Date: March 6, 2007  
 File No: 2158.04 (lcf)

Re: Comments on Draft EIR/EIS for Wetland and Creek Restoration at Big Lagoon, Muir Beach

## **Letter F: San Francisco Bay Regional Water Quality Control Board (March 6, 2007)**

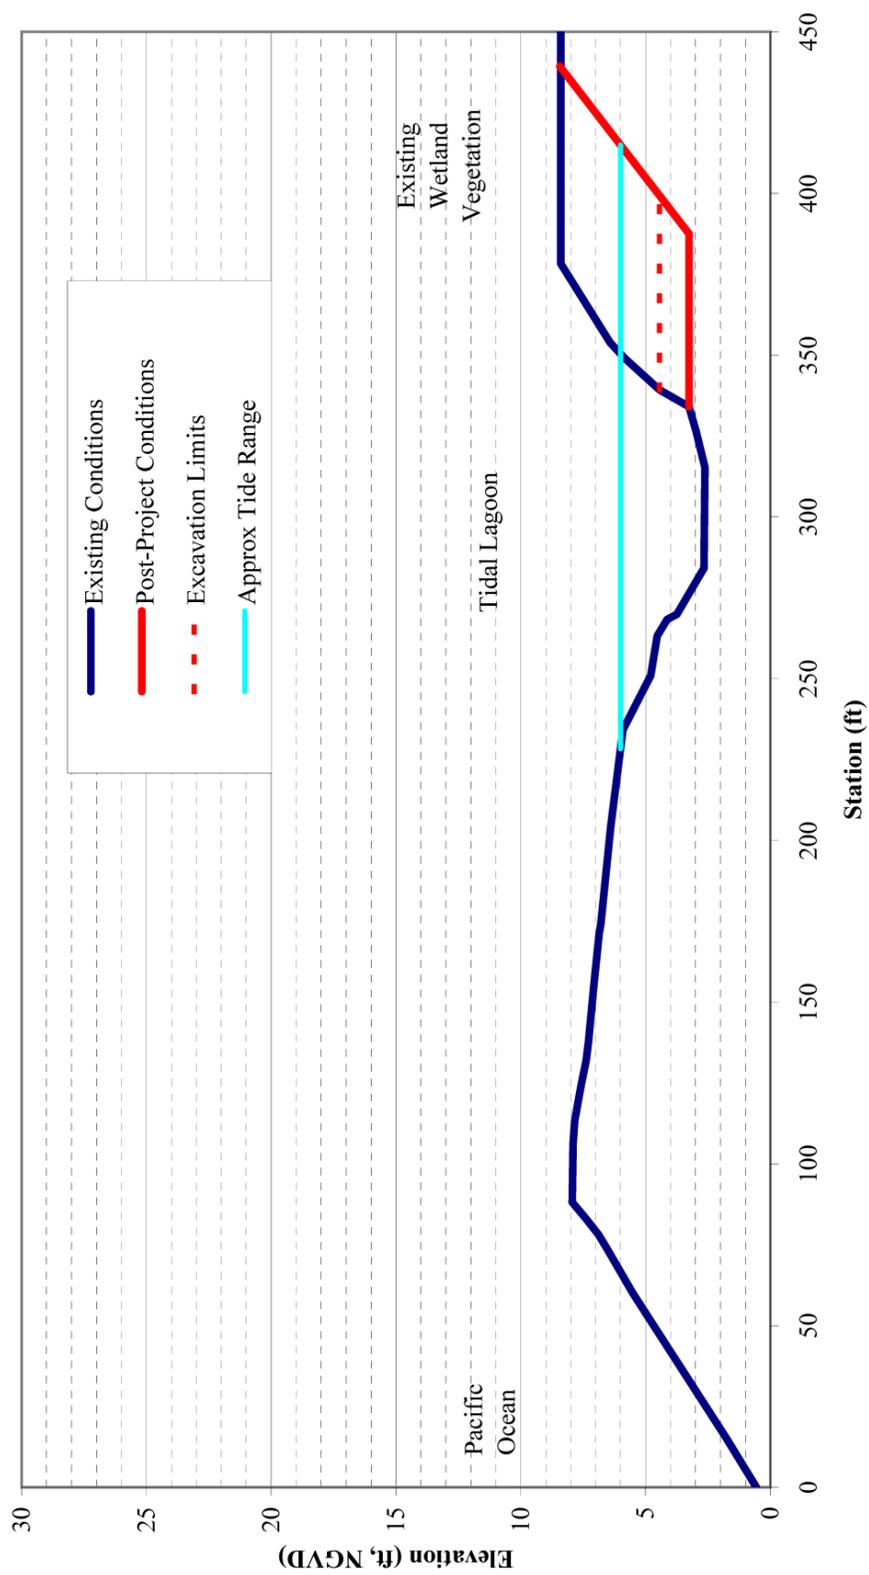
The DEIR/S (p. 4-35) concludes that none of the alternatives are anticipated to alter the seasonal patterns or processes driving lagoon formation. The potential impact on lagoon closure of the increased size of the tidal lagoon is not explicitly discussed. We believe that this potential impact requires closer scrutiny because unanticipated alterations in the timing of lagoon closure in a few restoration projects along the California coast have created significant negative environmental effects.

Natural reopening of a closed inlet occurs when the water level on one side of the beach barrier exceeds the elevation of the beach crest. This can occur either when high runoff fills the lagoon or when high storm surge tides occur. After the lagoon fills, the ebbing tide allows discharge from the lagoon by scouring a channel at the lowest point on the beach barrier. This breaching mechanism is affected by the wave run-up, the storm surge, the antecedent topography of the beach barrier, and the storage capacity of the lagoon.

Enlarging the tidal lagoon could potentially have the potential to delay lagoon opening if (a) the water surface were decreased because of increased storage volume (taking longer for the lagoon to fill to a critical elevation), or (b) losses from seepage or evaporation were increased. However, based on our evaluation of these two conditions (as described below), changes to the timing of lagoon opening is not likely.

We quantified the expected volume change to evaluate its potential to affect the timing of lagoon opening. The additional storage volume was estimated as approximately 4,000 cubic yards, based on the excavation volume plus expected scour (see Figure 6-4 for a schematic showing the lagoon cross-section). Assuming a constant base flow of 0.5 cfs (based on typical flows during the months of October and November), this additional lagoon volume will fill in less than 3 days. During a storm event, the additional lagoon volume would fill much faster (e.g., a 10 cfs inflow would fill this additional lagoon volume in 3 hours).

Based on cross-section R from the 2003 EDS ground survey, modified to reflect the relatively flat wetland area approx 100 feet upstream.  
 Estimated tide range based on maximum tide range of approximately 3 feet (PWA, 2004), assuming beach configuration at the time of the 2003 ground survey.
